Revised STAFF REPORT AND RECOMMENDATION TO THE DESIGN COMMISSION

CASE FILE: LU 16-111127 DZM AD
PC # 15-229299
SW 3rd & Salmon
REVIEW BY: Design Commission
WHEN: June 16, 2016 @ 1:30pm
(Continued from May 5, 2016)
WHERE: 1900 SW Fourth Ave., Room 2500A
Portland, OR 97201

Proposal: The applicant proposes a new 20-story hotel building with an FAR of 11.7:1; the additional 2.7:1 FAR above the 9:1 base allowed is achieved via the locker room bonus (33.510.210.C.8). The building is proposed to feature ground level retail, with restaurants at both corners and a central lobby facing SW Salmon. A secondary entrance at SW 2nd would lead to a rooftop bar with rooftop terraces, including a shallow pool. One loading space is proposed at SW 2nd Avenue. Exterior materials include dark burgundy brick, warm gray metal panel, dark gray spandrel glass, and glass curtain wall. The proposal will require the demolition of the existing Albion Hotel (Lotus Cardroom & Café).

3RD & SALMON / PORTLAND, OR
C.50 ELEVATIONS - EAST - SW 2ND

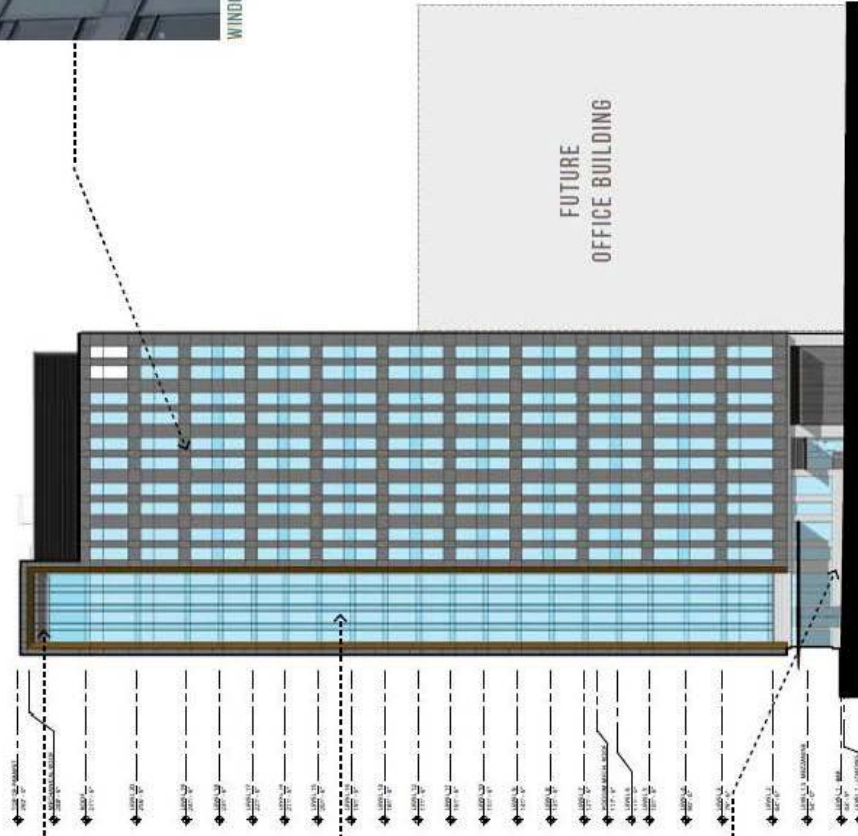
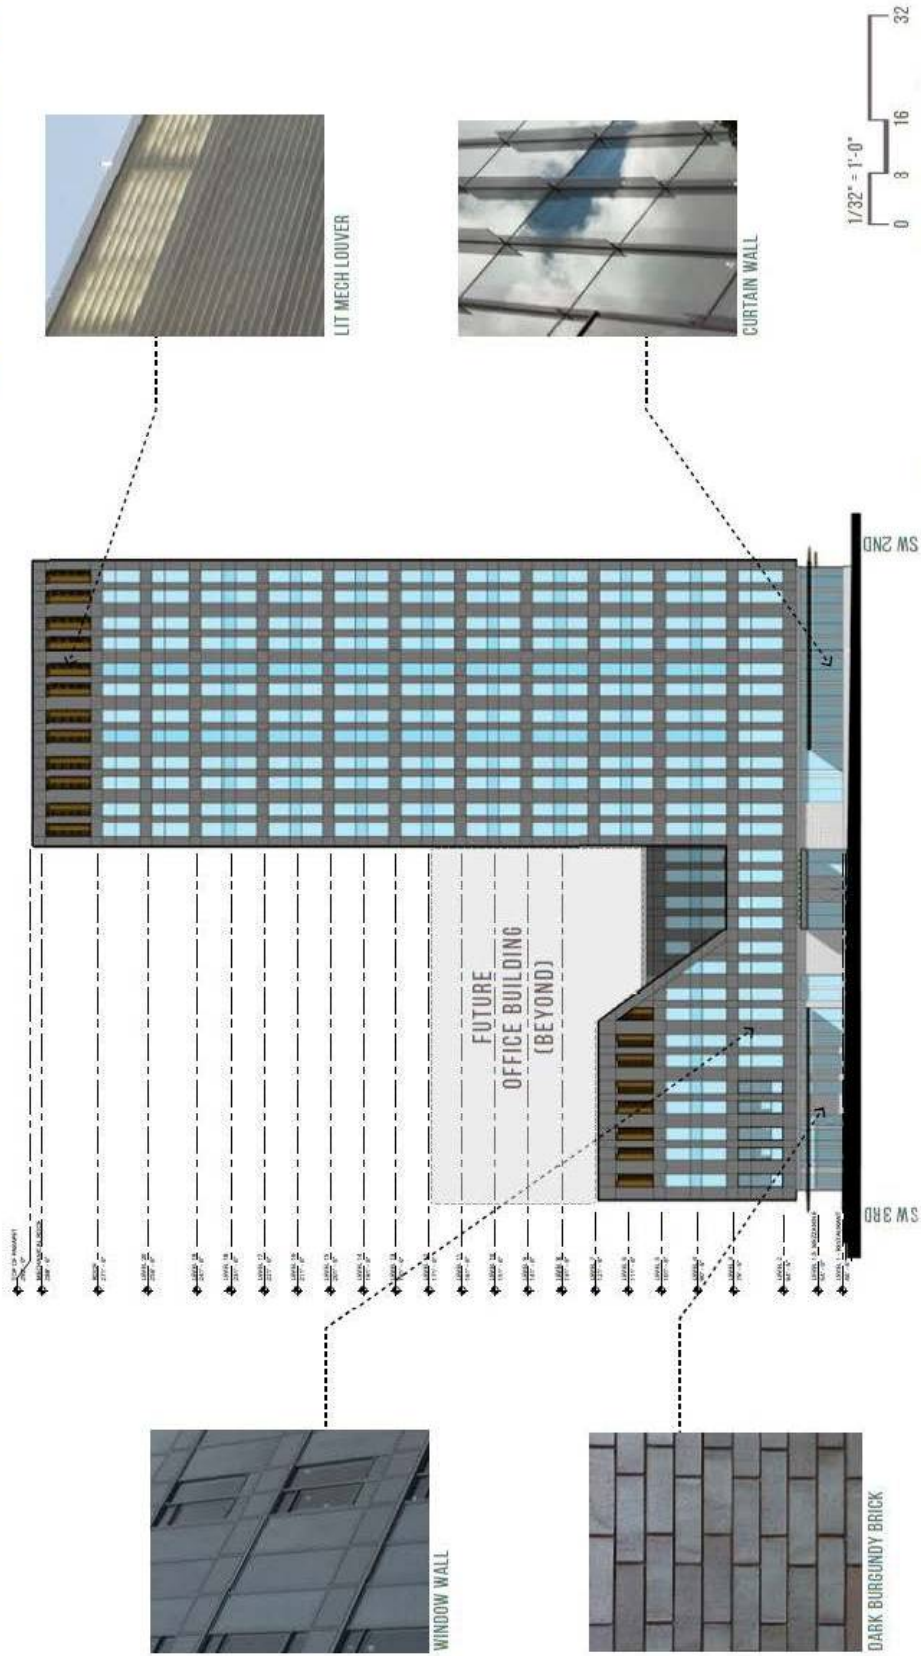
While not indicated on the plans, the applicant has stated that the bronze metal panel is also 18 gauge. Staff believes that in order to be successful, the beveled bronze frames around the curtain wall have to be of the highest quality and suggests that composite metal panel may be more appropriate here in order to ensure clean flat lines within this frame. In addition, staff suggests that the frame element on the east façade should be closed at the bottom to match the frame on the west. Staff also suggests that adding the 8-inch fins to the lower floors of the curtain wall, at a length greater than is shown on the west, would also help achieve a more cohesive expression, while highlighting the additional height at the east end of the building.

The applicant has also noted that the metal panel located at the base of the wall adjacent to the speakeasy entrance and the metal panel at the loading bay is also 18 gauge. Staff believes that the metal panel at the speakeasy entrance should be revised to brick in order to be more durable and more coherent. In addition, the metal panel at the loading bay should also be revised to a composite metal panel or steel in order to ensure durability.

- **The beveled bronze metal accents shall be composite metal;**
- **The east frame shall be closed on the bottom to match the condition on the west;**
- **8-inch deep fins shall be added to the east curtain wall, similar to the condition on the west, but for a greater length;**
- **The metal panel stem wall at the speakeasy entrance shall be revised to brick; and**
- **The metal panel at the loading bay shall be revised to composite metal panel or steel;**

- D. The beveled bronze metal accents shall be composite metal panel; the east frame shall be closed on the bottom to match the condition on the west; 8-inch deep fins shall be added to the east curtain wall, similar to the condition on the west, but for a greater length; the metal panel stem wall at the speakeasy entrance shall be revised to brick; and the metal panel at the loading bay shall be revised to composite metal panel or steel.
